ADDENDUM No. 1

**Sealed Bid # 12-5637
CCT Mobility Center (Paratransit Facility)**

DATE: February 17, 2012

CCT ADDENDUM NO. 1
NBA Project No. 110044.00
February 16, 2012

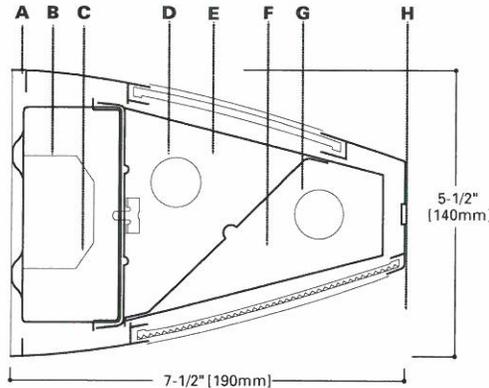
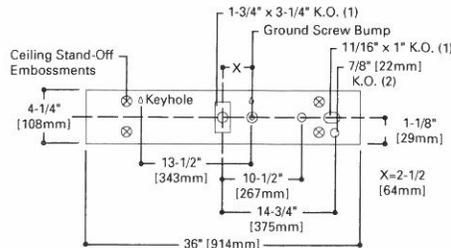
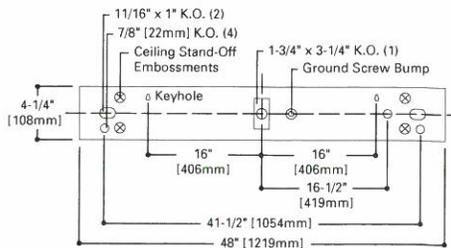
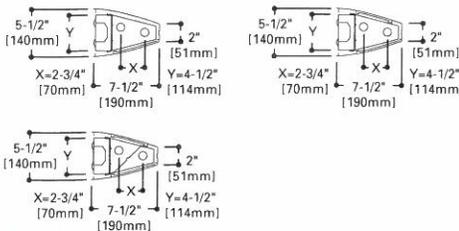
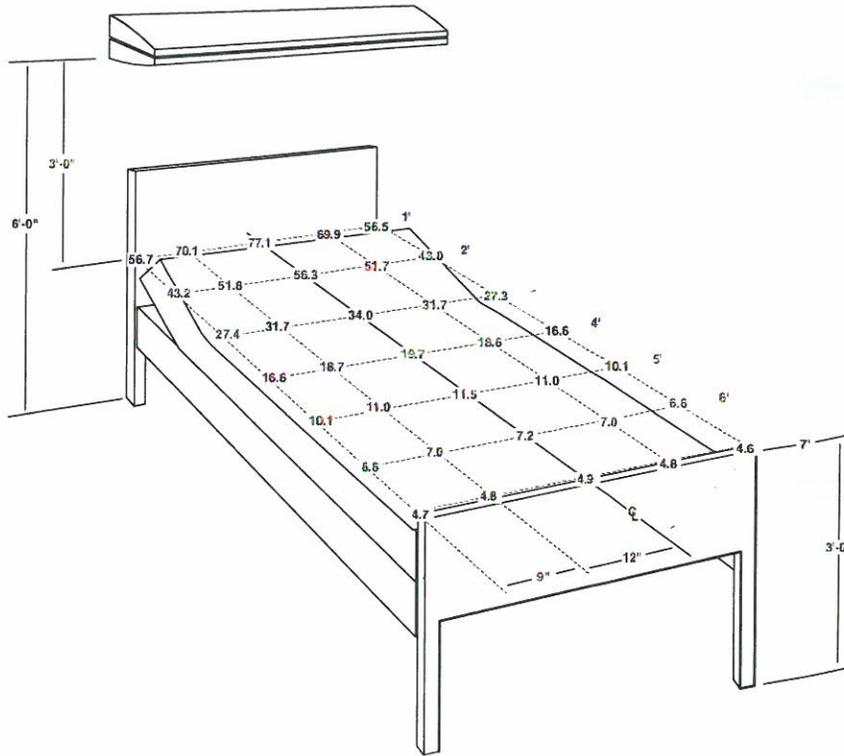
Q.9 Sheet E2.0 Shows a Type “J” Fixture in the Men’s and Women’s restrooms, there is no fixture shown for this designation on the fixture schedule. Please provide a fixture type or allowance amount to be carried.

A.9 Provide attached “J” type fixture or equivalent. (See attached Type “J” fixture cut sheet).

EXISTING MSA SWITCHBOARD

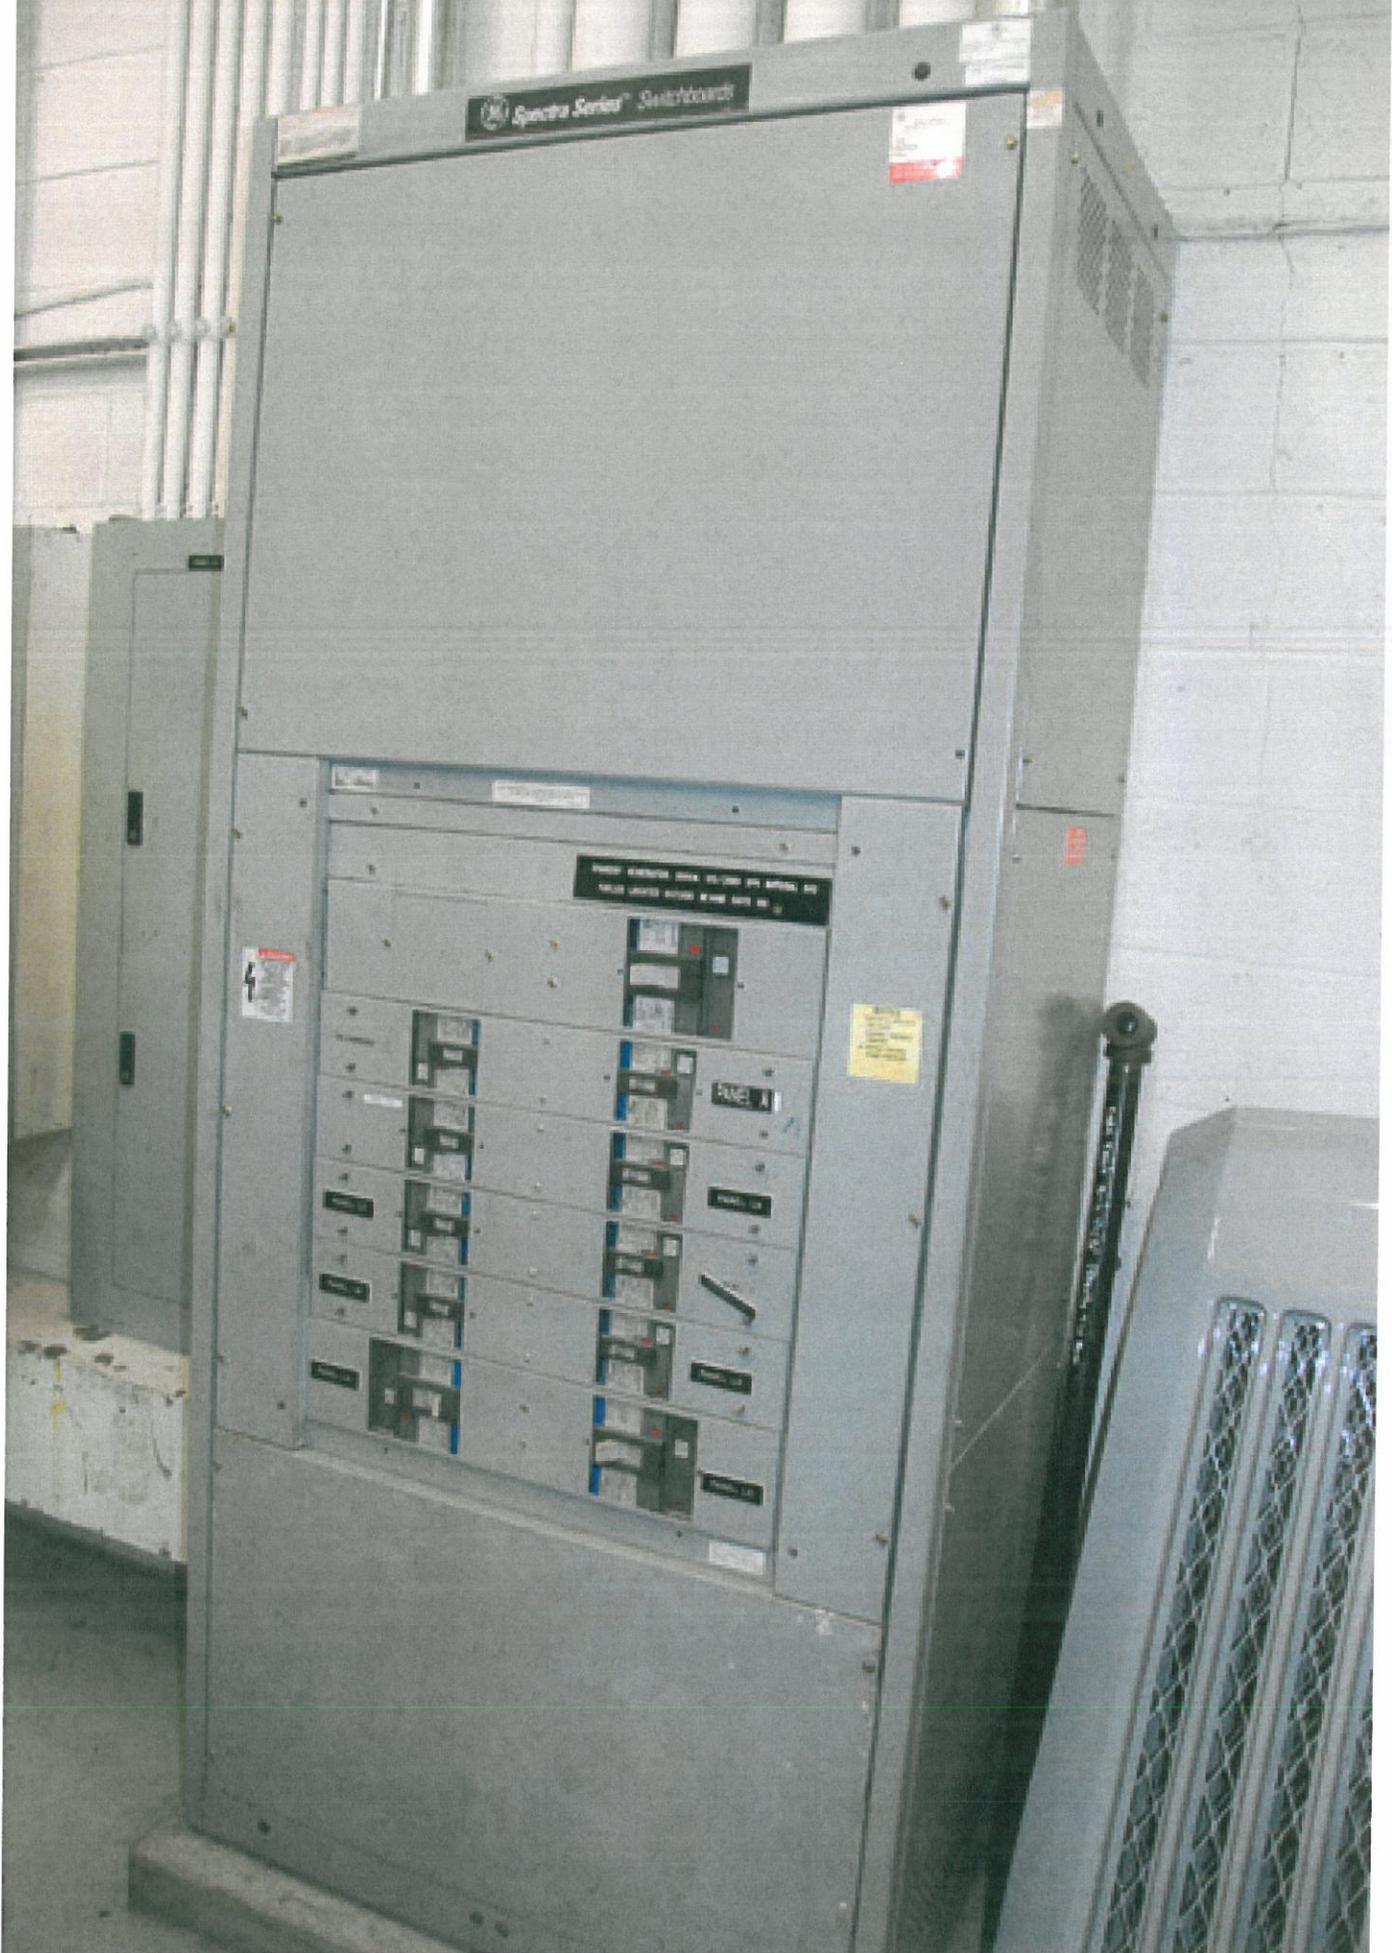
Q12. In the existing Maintenance Building Switchboard MSA is being utilized to feed Panel 1L22 in the new addition for the Maintenance Building. Who is the manufacturer of this switchgear and what is the model of the gear?

A.12 There is a combination of Cutler-Hammer, Square D, and GE electrical equipment on site. Per photograph, the existing MSA switchboard appears to be GE Spectra Series. (See attached existing MSA switchboard photograph).
